# Administrative Approval Action

Case File / Name: SUB-S-17-2019 FARRIOR HILLS BLOCK J LOT 8 SUBD City of Raleigh
Development Services Department
One Exchange Plaza
Raleigh, NC 2760
(919) 996-2492
currentplanning@raleighnc.gov
www.raleighnc.gov

# PRELIMINARY SUBDIVISION PLAN for FARRIOR HILLS, BLOCK "J" EXISTING LOT 8

CITY OF RALEIGH, WAKE COUNTY, NORTH CAROLINA
CASE #: SUB-S-17-2019
Transaction #: 592122

SHEET 3 OF 5 - SUBDIVISION & SITE PLAN

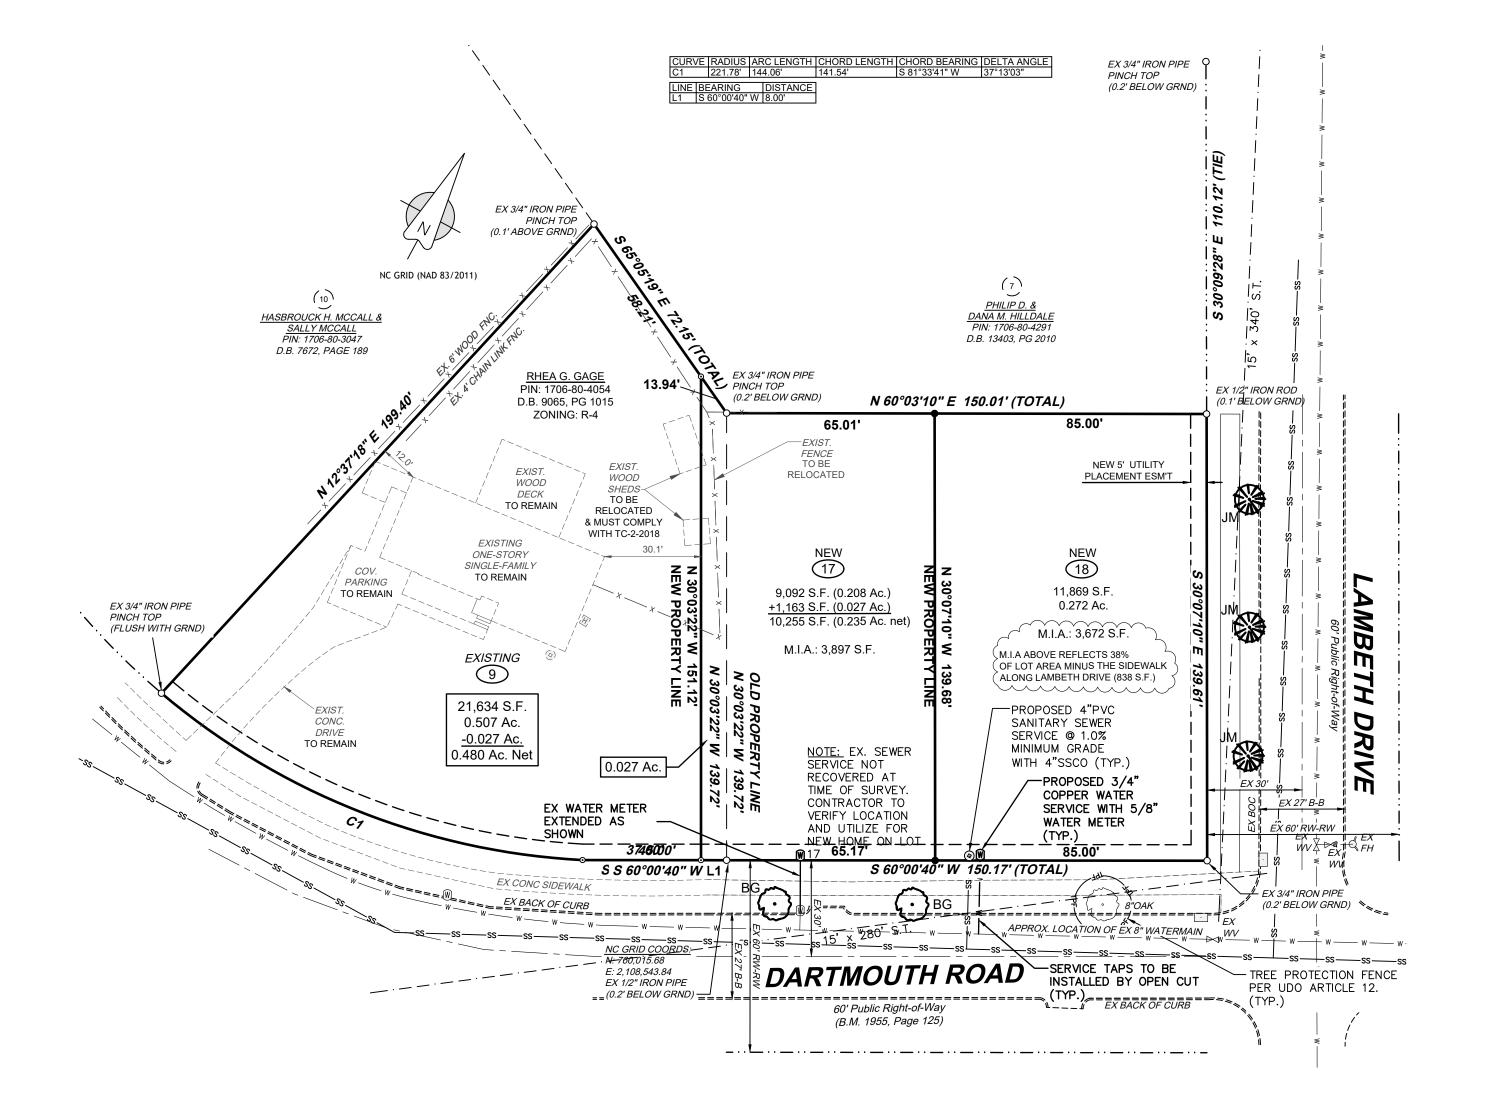
- 4. A public infrastructure surety is provided to the City of Raleigh Development Services Development Engineering program (UDO 8.1.3) for the proposed sidewalk on Lambeth Drive.

- A fee-in-lieu for the difference between the required 6-ft width and the existing variable width of sidewalk (which is less than 6-ft) along the Dartmouth Road frontage for all 3 parcels is paid to the City of Raleigh (UDO 8.1.10).

- 7. A public infrastructure surety is provided to the City of Raleigh Development Services Development Engineering program (UDO 8.1.3) for the street trees on Lambeth Drive.

7. A tree impact permit must be obtained for the approved streetscape tree installation in the right of way. This development proposes 3 (shade) street trees along Dartmouth Rd, and 3 (understory) street trees along Lambeth Dr.
